**RESPONSE TO REQUEST FOR ADDITIONAL INFORMATION**

**US-APWR Design Certification  
Mitsubishi Heavy Industries  
Docket No. 52-021**

**RAI NO.:** NO. 852-6003 REVISION 3  
**SRP SECTION:** 03.07.02 – Seismic System Analysis  
**APPLICATION SECTION:** 3.7.2  
**DATE OF RAI ISSUE:** 10/24/2011

**QUESTION NO. RAI 03.07.02-113:**

Figure 1 FH/A Steel Column

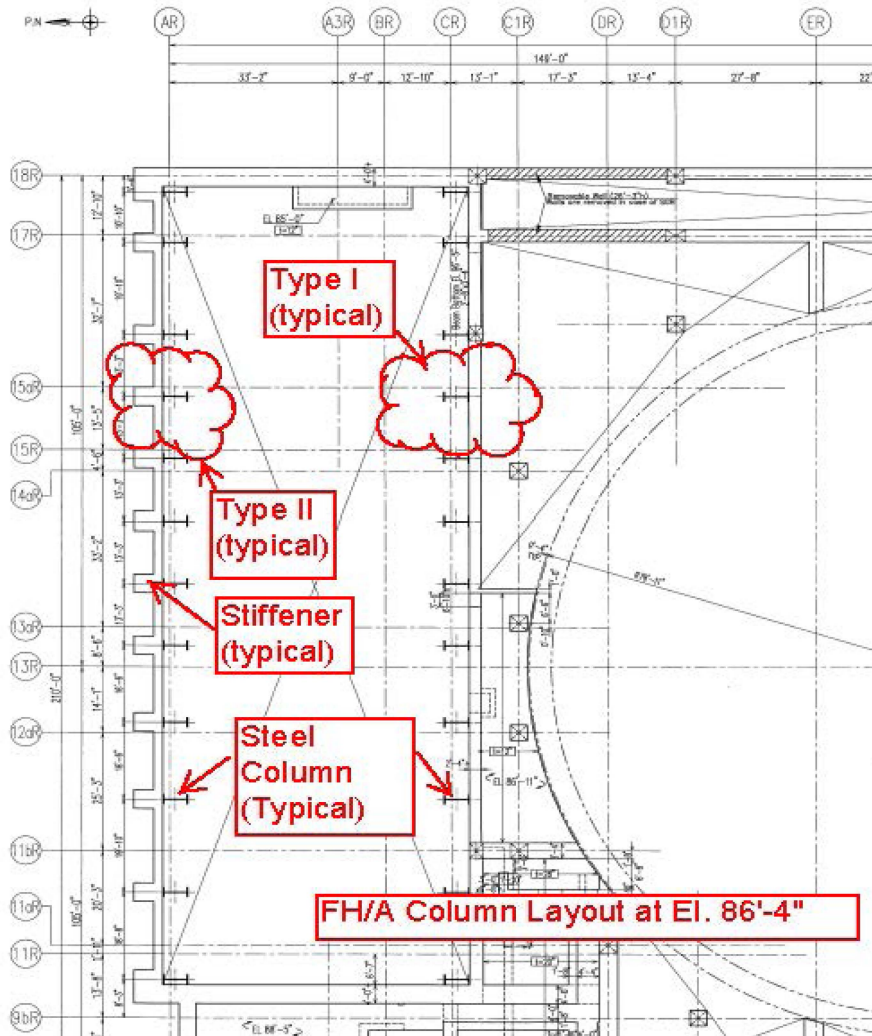
(iv) On page 4-28, it is stated that “the effective width of concrete (before transformation to steel section) is based on AISC 360-05, Section I3. The requirements in AISC 360-05 are applicable when the flange of the composite section is in compression. When the flange is in tension, smaller values of ‘be’ could be used.

Since the flange (concrete slab of the composite floor) may be in both tension and compression during earthquake excitation, a smaller ‘be’ would appear to be appropriate. AISC 360-05,

Section A1 refers to the provisions of ANSI/AISC N690 or ANSI/AISC N690L for nuclear safety-related structures.

The applicant is requested to confirm whether it has considered provisions of ANSI/AISC N690 or ANSI/AISC N690L in the calculation of 'b<sub>e</sub>'.

(iv) The provisions of ANSI/AISC N690 have been considered in the calculation of ' $b_e$ ' in addition to the provisions of ANSI/AISC 360-05. The sentences of Section I3 state, "Above requirements are applicable when the flange of the composite section is in compression. When the flange is in tension, smaller values of ' $b_e$ ' could be used," are not included in Technical Report MUAP-10006, Rev. 3. Two bounding stiffness levels are modeled in the SSI analysis. For the full stiffness case (uncracked), the composite beam stiffness is represented by the 75% linear equivalent stiffness of the transformed section under positive moment, which corresponds to the slab under compressive load and without cracking. The 75% is required per the Code to consider the difference in stiffness along the beam length. For the reduced stiffness case, no composite effect for the beams is considered. The stiffness of the steel beam alone is considered to model the out-of-plane stiffness of the beam supported slab/roof system, in addition to the reduced stiffness of slab/roof represented by 50% reduction of concrete Young's modulus.

As discussed with the Nuclear Regulatory Commission (NRC) staff during the Design Certification Document (DCD) Tier 2, Section 3.7.1, 3.7.2, and 3.7.3 Audit conducted in September 23-27, 2013, in regard to the Fuel Handling Area (FH/A), the crane supporting columns are continuously anchored to the walls. Similar to the steel beam supported slab/roof in FH/A, the stiffening effect of the steel columns on the out-of-plane stiffness of the wall are considered. Figure 1 presents the two types of wall/column configuration in FH/A. The stiffness consideration for Type I column/wall system for the FH/A south wall is the same as the one described above for the beam supported slab system, i.e. composite effect is considered for full stiffness case while steel column stiffness alone in addition to reduced slab stiffness is considered for reduced stiffness cases. As shown in Figure 1, for the Type II column/wall system, stiffener with sectional dimension of 4' x 4' is installed outside of the FH/A north wall at location of each column. The steel-concrete composite effects of the beam/wall/stiffener system on the out-of-plane stiffness of the wall are evaluated and considered for both cases of full stiffness and reduced stiffness. The methodology used for evaluation of the composite effects is described in Section 2.4.1.1.6 of MUAP 10006 Rev. 3. In the evaluation, the width of the outside stiffener is directly used as effective flange width " $b_e$ " for the Type II column/wall system. Uncracked concrete Young's modulus is used for full stiffness case and 50% of reduction of the Young's modulus is used for reduced stiffness case for the stiffener and the portion of the wall that function as a "flange" in composite section evaluation. Note 2 of MUAP-10006 Table 02.4.1.1.3-1 will be changed to reflect the differences in reduced stiffness for the columns in FHA.
